RESPONSE TO REQUEST FOR ADDITIONAL INFORMATION

US-APWR Design Certification

Docket No.52-021

RAI NO.: NO. 750-5675 REVISION 2
SRP SECTION: 19 – Probabilistic Risk Assessment and Severe Accident Evaluation
APPLICATION SECTION: 19
DATE OF RAI ISSUE: 04/28/2011

Figure 19.514-3 Time Variation of the RCS and Ruptured SG Pressure (1 out of 4)

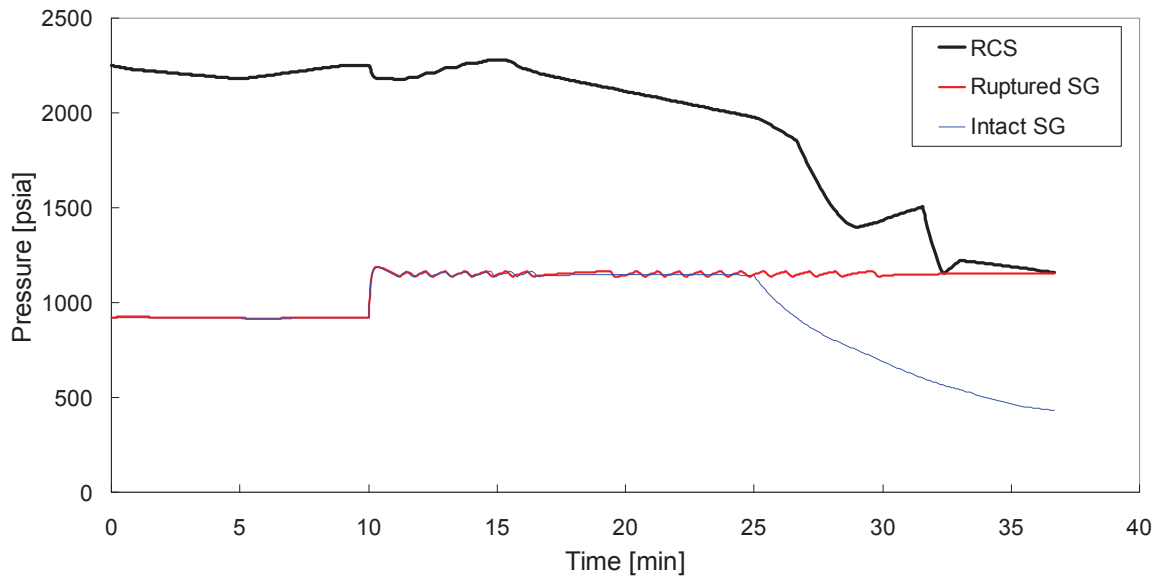
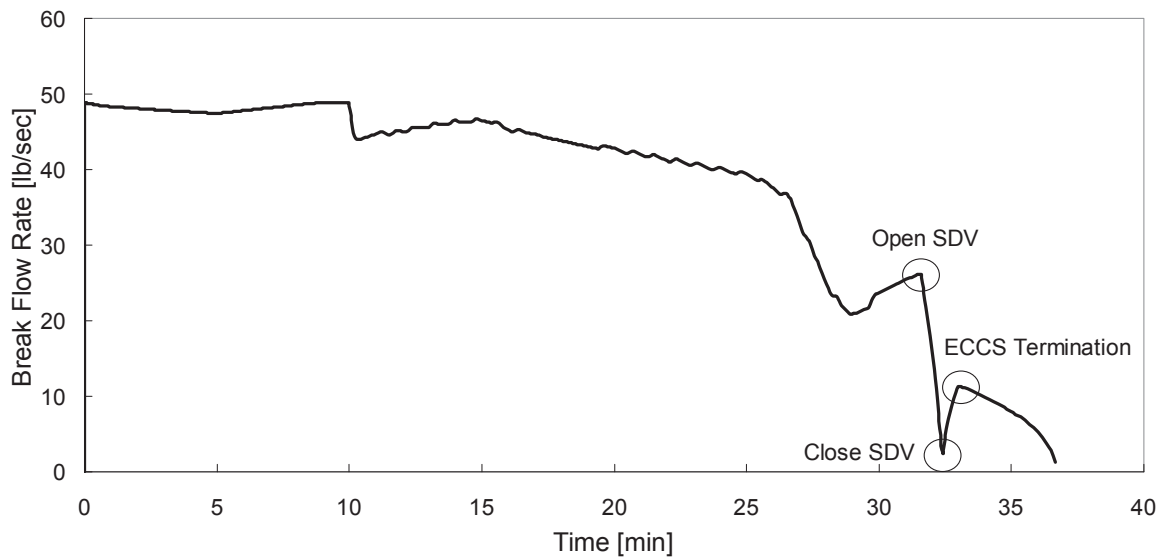
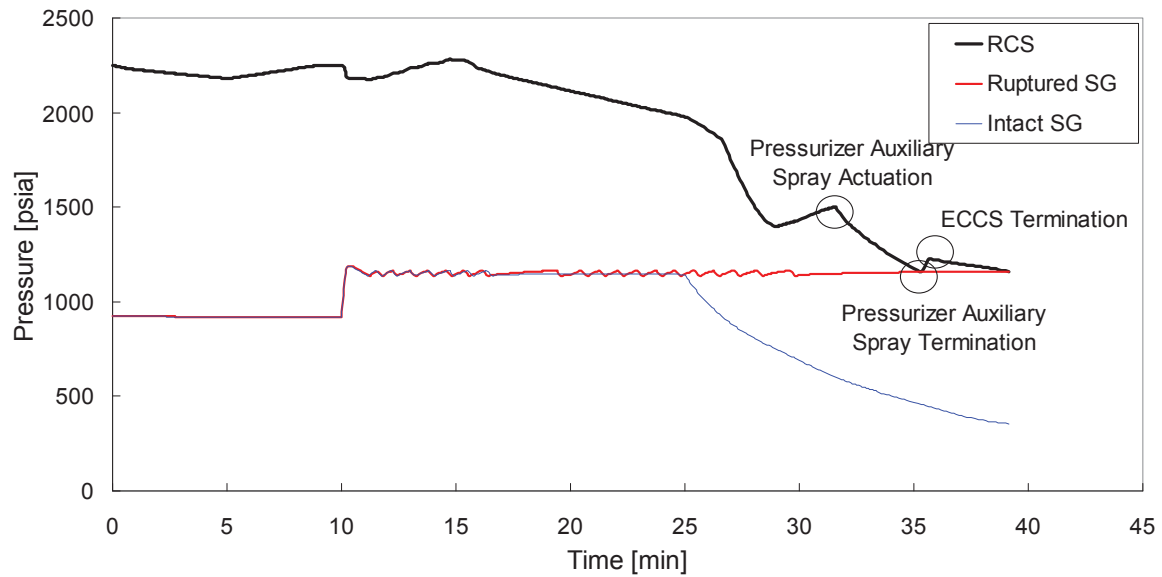
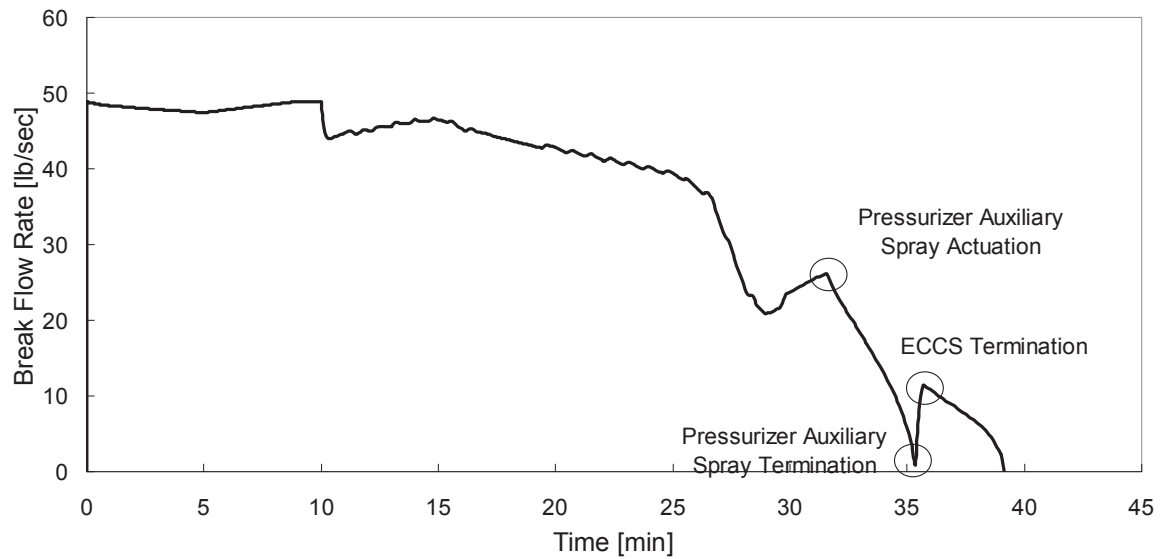
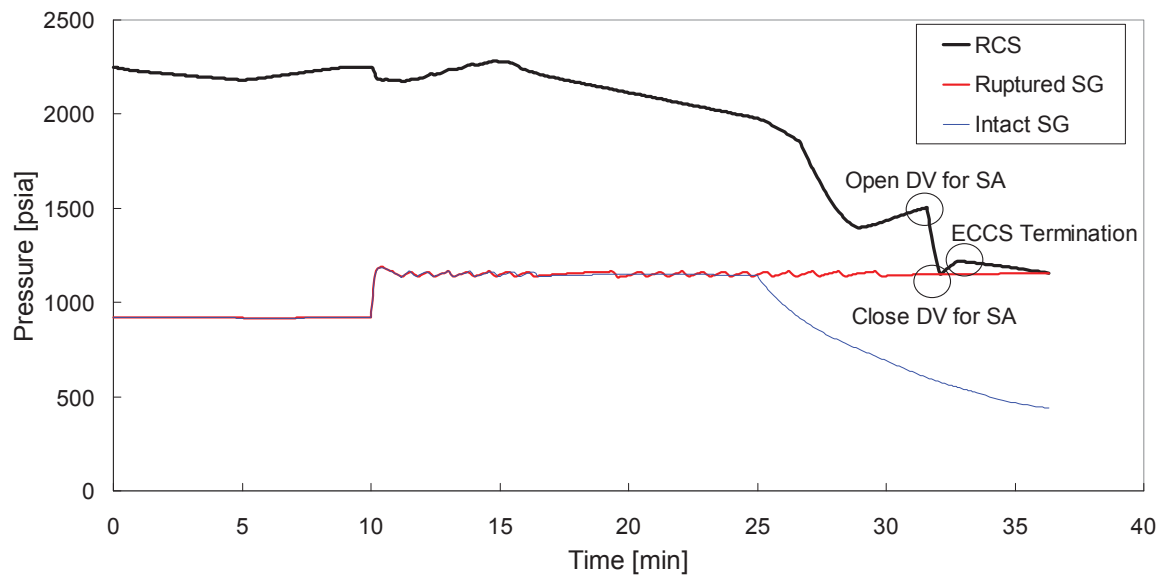
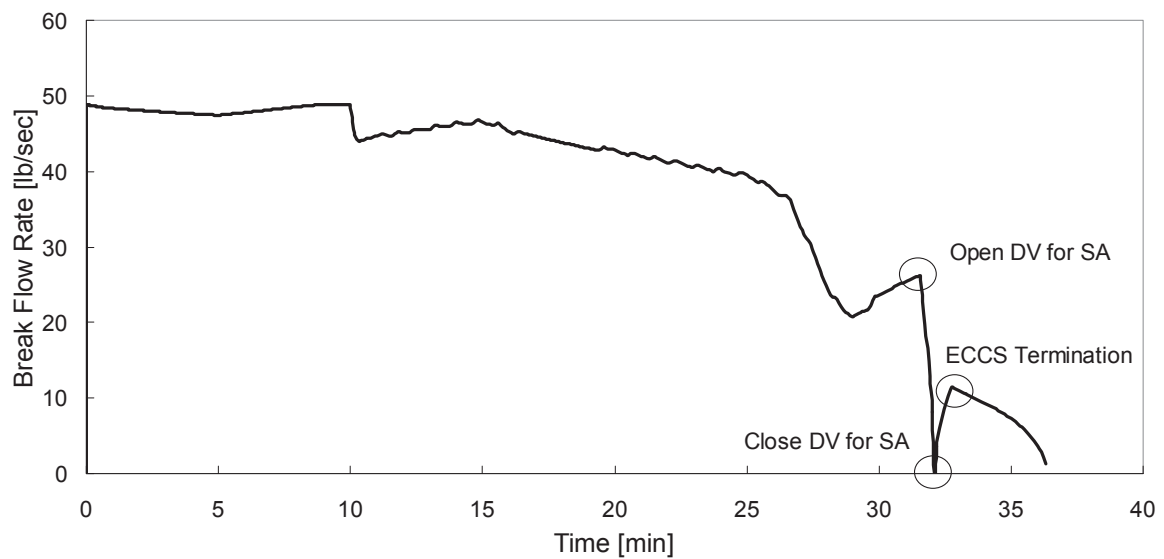
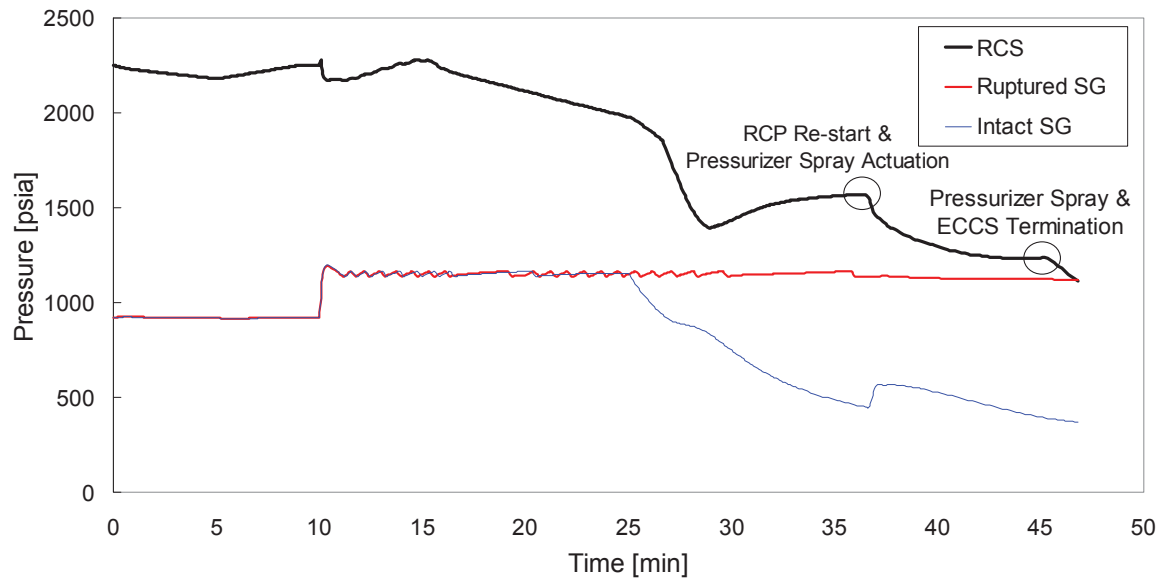
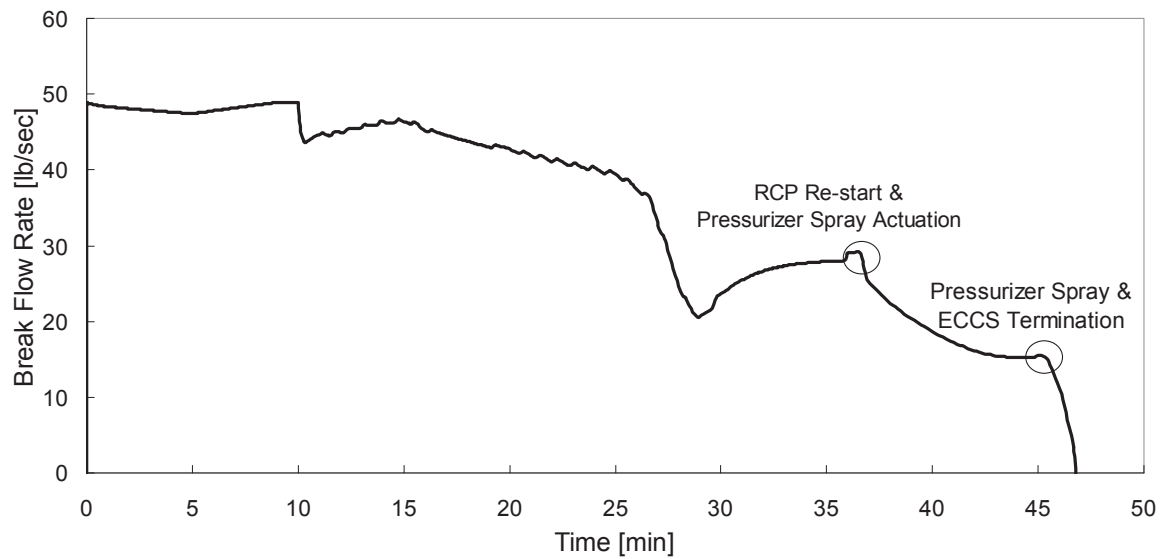
Other T-H analyses using the MARVEL-M code were conducted to demonstrate that there are multiple methods for operator action to depressurize the RCS ("pressure equalization"), based on the system conditions described in Table 19.514-2. Table 19.514-3 and Figure 19.514-3 show the analysis results and time variation of pressure of the RCS, a ruptured loop and intact loop for each case, respectively. In all cases, any of the four operator actions identified earlier can depressurize the primary system. For Cases 1 through 3, when RCS pressure is depressurized down to the ruptured SG loop pressure, the depressurization action is terminated. After that, the RCS is slightly pressurized due to the decay heat from the reactor core, eventually ECCS (i.e., SI pumps) termination will stop leakage via the ruptured tube. For Case 4, pressurizer spray with re-starting RCPs can depressurize the RCS and ECCS termination enables leakage from the ruptured tube to stop, as well as Cases 1 through 3. These results show that there are multiple options for operator action to depressurize the RCS. The analysis result will be added in DCD Table 19.1-15, No. 3.8.
